CITY OF GARDEN CITY

File Number: DSRFY2022 - 0001
Application Scope: Pre-Application Conference
Title 8 Use: Service Provider and Vehicle Service
Location: 6845 N. Gardner Ln.
Applicant: Jeff Hatch
Report Date: November 1, 2021
Revision Date: TBD

Staff Report
Prepared by Hanna Veal

③ WEST ELEVATION
1/8" = 1'-0"

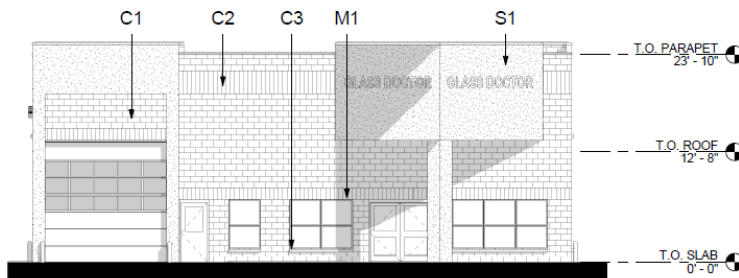
8-4A-8 Utilities	DC	Complaint as Conditioned	<p>All surrounding utilities appear to be underground.</p> <p>A draft condition of approval is provided requiring that all utilities be underground.</p>
8-4C-3 Design Provisions for Nonresidential Structures	DC	Not Complaint	<p><i>Objective 1: The design of all structures shall have a scale, massing and urban form that has a relationship to the street, the pedestrian, and adjacent properties.</i></p> <p>Mostly Compliant. Code states that the maximum front setback is 15ft from curb edge for a minimum of 60% of the length of street frontage.</p> <ul style="list-style-type: none"> - The setback from the existing back of curb along N. Gardner Lane is about 15ft for 72.2ft in length. - The setback from back of existing curb along W. Carlton Bay Drive is unknown. The application proposes to remove the existing attached sidewalk and replace it with parking space. This parking lot placement is in direct conflict with GCC 8-4C-3B Objective 2 and GCC 8-4D-3. - The first-floor façade visible from both W. Carlton Bay and N. Gardner Street do not address the pedestrian at street level. First floor facades visible from a public street should include surfaces in windows, showcases, displays, or pedestrian access elements for at least 15% of the surface. - The south elevation along W. Carlton Bay Drive and the east elevation along N. Gardner Ln. have large blank areas, corresponding with the vehicle service area. Windows or other design elements as listed in

<p>Objective 1, Subsection 7 (if privacy is a concern) could be incorporated to break up the façade.</p> <p><i>Objective 2: The design layout of all sites shall maximize opportunities for safe and comfortable pedestrian accessibility and minimize the obtrusive effects of parking and vehicular circulation.</i></p> <ul style="list-style-type: none"> - The parking lot placement along W. Carlton Bay Drive is in direct conflict with 8-4C-3B parking lot locations. <ul style="list-style-type: none"> o All parking lots should be located to the side and rear of the building fronting on the street unless otherwise screened by vegetation. - The site does not propose direct pedestrian connection between the private street sidewalks and the primary entrance of the building. Direct, convenient, and attractive pedestrian pathways should be provided that are clearly marked and connect all portions of the site. <ul style="list-style-type: none"> o It does propose a connection to Human Bean which has a connection to the public sidewalk on State Street. This connection shall remain. And the colored striping shall be maintained so that it is always visible. - The primary entrance is not compliant with code. The building closest to the street should have its primary entrance to the street and be clearly defined by the architectural design of the building. W. Carlton Bay Drive or N. Gardner Lane shall be considered the street to which the front shall face. <ul style="list-style-type: none"> o This provision might conflict with the overall site plan given that the internal drive isle and parking have already been developed. If the building were to face the street, there would likely need to be a secondary entrance out of convenience for those who are walking to the site and parking in the parking lot. <p><i>Objective 3: Buildings shall be designed and constructed of quality materials.</i></p> <ul style="list-style-type: none"> - Appears compliant. Primary materials will be a combination of CMU, blue stucco, and brick accents. <p><i>Objective 4: The site design shall respect existing notable site features including existing buildings, landscaping, trees and water.</i></p> <ul style="list-style-type: none"> - Not applicable. Site appears to be scraped. <p><i>Objective 5: The design of all buildings shall provide visual interest, support the vision for the area as articulated in the comprehensive plan and positively contribute to the overall urban fabric of the community.</i></p> <ul style="list-style-type: none"> - The proposed building orientation appears to be in conflict with Garden City Code. Buildings should be oriented to a prominent feature, such as a corner location, a plaza, a street or the river. Buildings and site design should provide inviting entry orientation.

<p>Buildings should not turn their backs to the street. Building is oriented inward instead of toward a public street. However, additional design features along streetside facades could create an outward orientation.</p> <p><i>Objective 6: The site development should support and be consistent with the adopted streetscape.</i></p> <ul style="list-style-type: none"> - Not applicable. A streetscape has not been adopted for W. Carlton Bay Drive or Gardner Lane.
8-4C-5 Prohibitions	DC	No compliance issues noted	<p>There are no visible false fronts, prefabricated structures or prohibited materials proposed with this application.</p> <p>It does not appear that any crushed colored rock/crushed tumble glass is utilized on the site.</p>
8-4D Parking and Off Street Loading Provisions			
8-4D-3 Parking Design and Improvement Standards	DC	Not Compliant	<p>The application will need to re-orient their parking spaces. The site plan proposes to remove the section of existing attached sidewalk along W. Carlton Bay Drive and replace it with vehicular parking. This is in direct conflict with Garden City Code as it states:</p> <ul style="list-style-type: none"> - Parking lots shall not be located within forty feet (40') of a corner. - Parking areas shall be designed in such a manner that any vehicle leaving or entering the parking area from, or onto, a public or private street <u>shall be traveling in a forward motion</u>. Except for an alley and parallel spaces, driveway configurations which require backing in, from, or out onto the street, are not allowed.
